5.4 Components and Subsystem Design

The information in this section of the reference ABWR DCD, including all subsections, tables and figures, is incorporated by reference with the following departures and supplements.

Figure 5.4-1 Reactor Internal Pump Cross Section

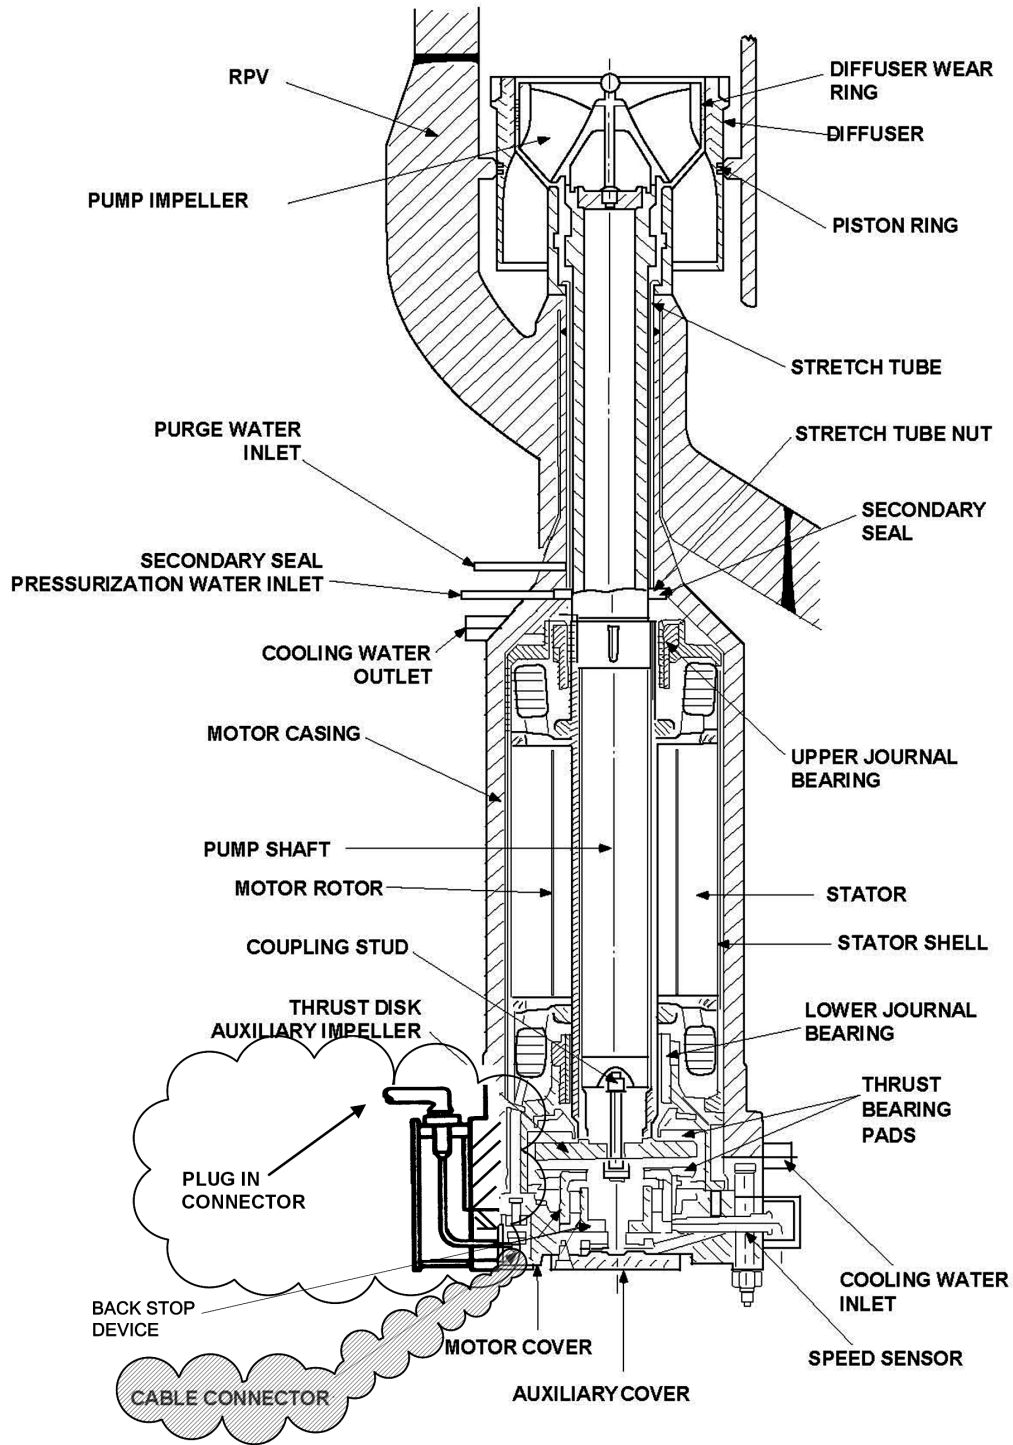
[STD DEP 5.4-2 \(Figure 5.4-1\)](#)
